Enclosure (1) is the Final Parcel E Nonstandard Data Gaps Investigation Landfill Lateral Extent Evaluation. This report is provided for your information.

Enclosure: 1. Final Parcel E Nonstandard Data Gaps Investigation Landfill Lateral Extent Evaluation, Hunters Point Shipyard, October 29, 2004

This document discusses data collected for, and results of, an investigation to assess the extent of solid waste at the Industrial Landfill in Installation Restoration Site 01/21 of Parcel E (hereinafter referred to as the Landfill) at Hunters Point Shipyard (HPS) in San Francisco, California. This work was conducted as part of the Parcel E nonstandard data gaps investigation under the protocols set forth in the "Draft Final Field Sampling Plan and Quality Assurance Project Plan [FSP/QAPP] for Parcel E Nonstandard Data Gaps Investigation (Industrial Landfill and Wetlands Delineation), HPS, San Francisco, California," dated January 8, 2002. This report is part of the revised remedial investigation and feasibility study for the Landfill at HPS. The results from this evaluation will be used to assist in development of the final remedy for the Landfill.

FIGURE 4
REVISED LATERAL DELINEATION
WITH AERIAL PHOTOGRAPH

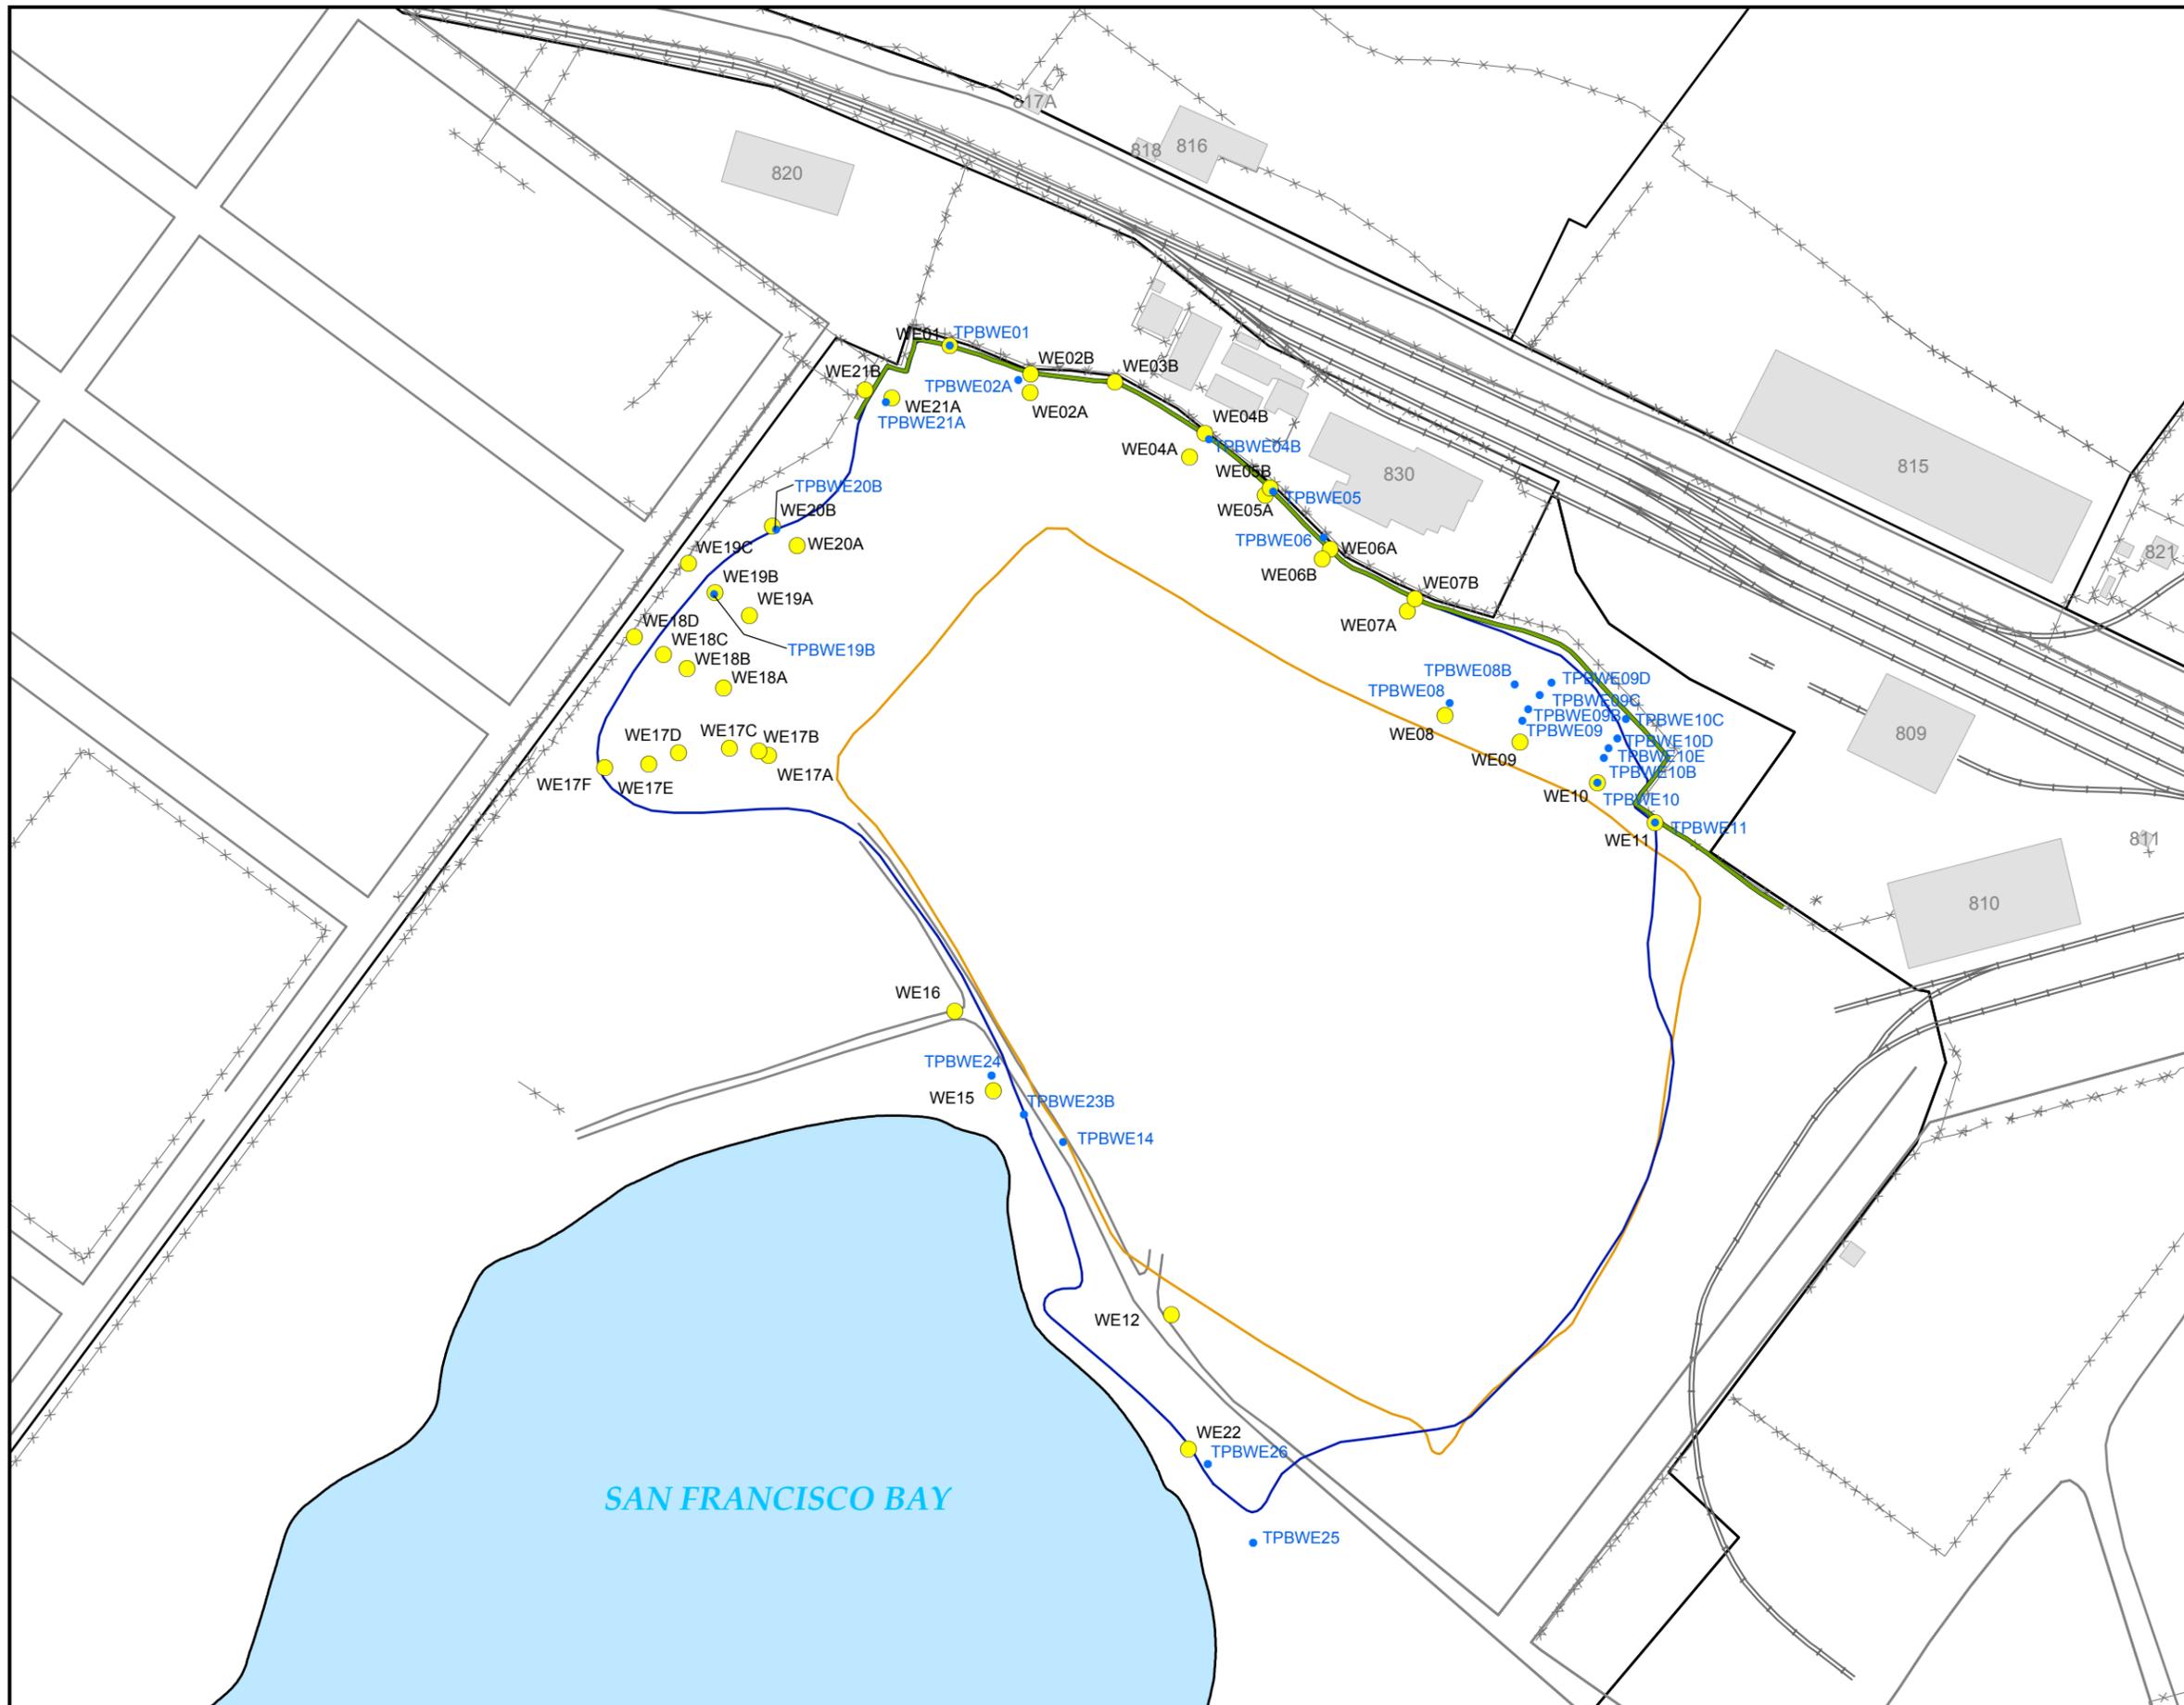
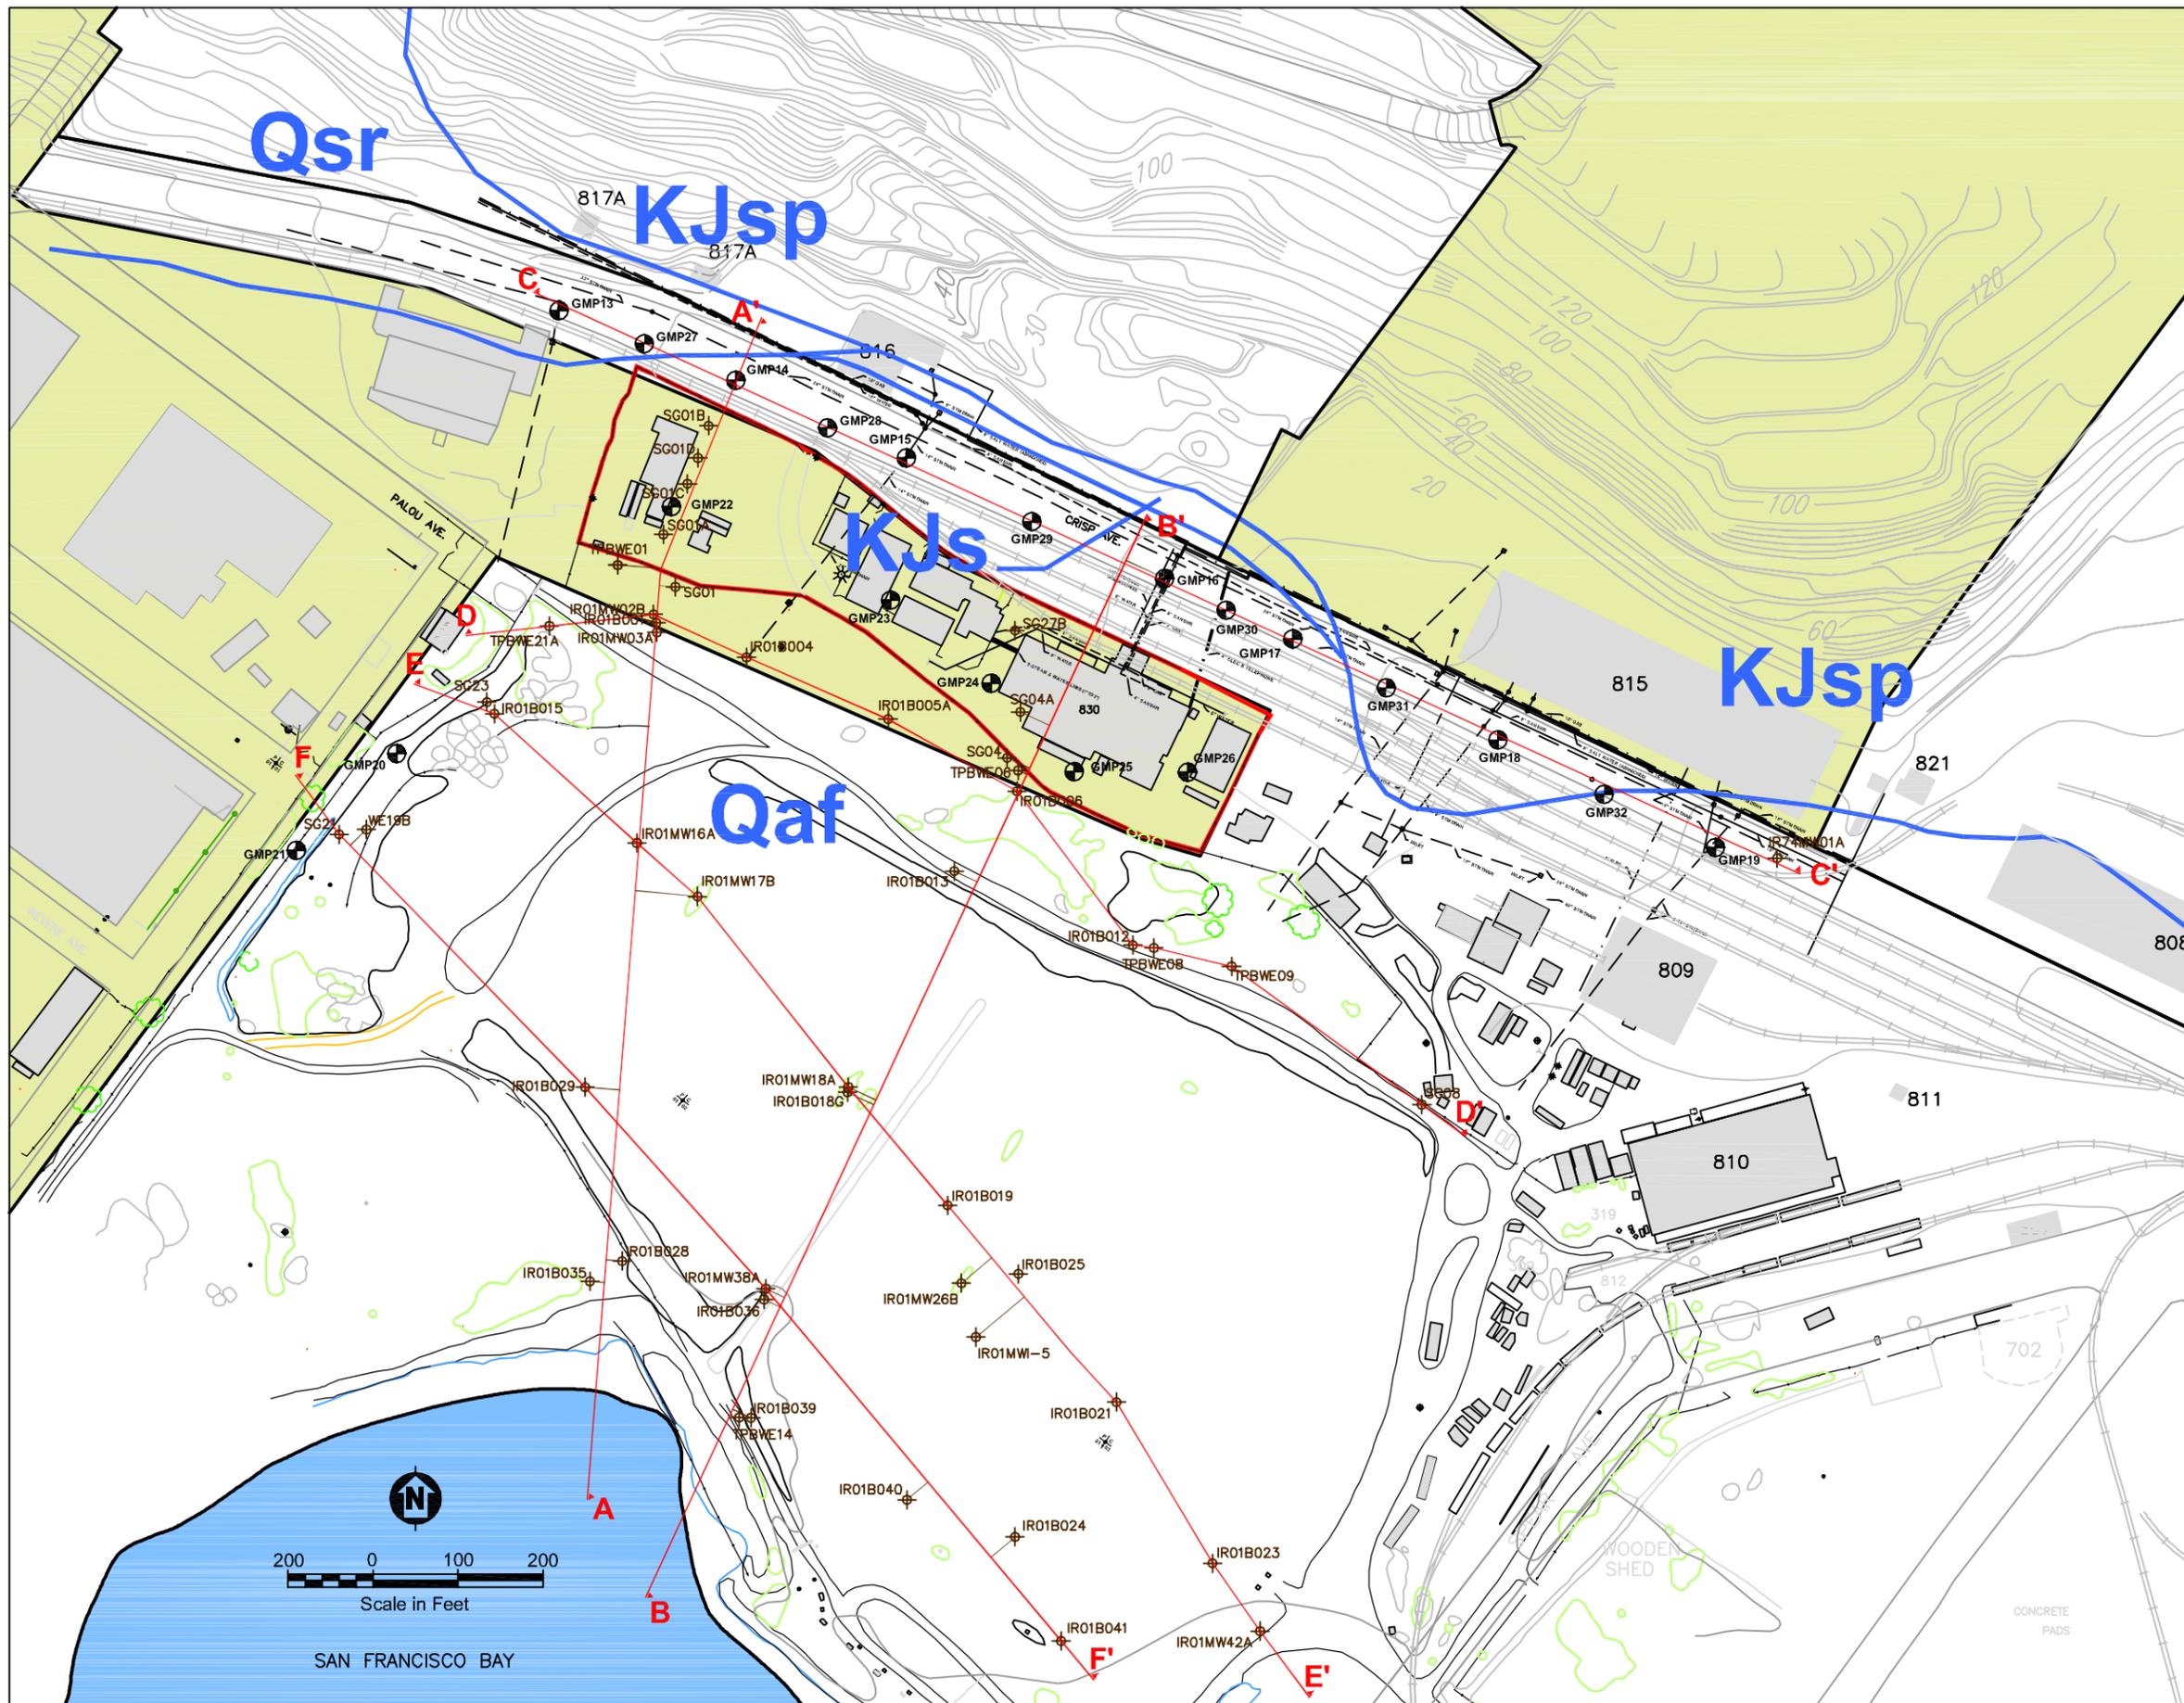
- Comment:** **Figures 4 and 5, Revised Landfill Extent:** It is unclear how the landfill boundary was determined along about 300 feet of the southwestern edge (between C25 and IR10B028), because there are no borings or test pits. Please explain why test pits or borings were not done in this area and how the extent of waste was determined. Similarly, it is unclear how the eastern extent of waste was determined; the description in Section 3.2.2 explains that this is based on aerial photographs and maps, but this information is not provided and there is only one boring (IR01B023) near the boundary along an 800 or 900 foot perimeter. Please explain why the eastern extent of waste should be considered accurately represented by the smooth curve drawn on these figures when the western edge of waste is fairly irregular and provide the maps and aerial photographs that were used to make this determination.

Errors. The log is titled "TPBWE05" but Figure 2 shows the location as "TPBWE05-2". And, the log says "TPBWE06", but Figure 2 says "TPBWE06A ". Similarly, should "WE05" on Figure 2 be changed to "WE05-1"?

Figures 1, 2, and 4. UCSF property extends to the Hunters Point property boundary. Please revise figures and text accordingly.

Figure 4. Please include GMPs.

Response: The areas investigated included the Landfill's northwestern and northern perimeters and the Landfill's southern perimeter adjacent to the Bay. Neither the southwestern nor the eastern landfill perimeters were included for investigation in the FSP/QAPP.

The Navy has revised the landfill extent shown on [Figures 4 and 5](#) to include borings WE01 and TPBWE01 within the landfill extent, and the text has been revised to state that waste was found in boring WE01. Wood debris and fragments do not necessarily constitute waste because both can be construction debris fill. Similarly, petroleum staining indicates an impact, but is not a criterion for identifying solid waste.

On [Figure 4](#), borings TPBWE05A and TPBWE06A have been revised to borings TPBWE05 and TPBWE06. On [Figures 2, 3, and 5](#), borings TPBWE05-2 and TPBWE06A have been revised to borings TPBWE05 and TPBWE06. On [Figures 2 through 5](#), borings WE05 and WE05-2 have

[Figures 1, 2, and 4](#) correctly show the property boundary between HPS and the University of California at San Francisco property.

The locations of the gas monitoring probes have been added to [Figure 4](#).
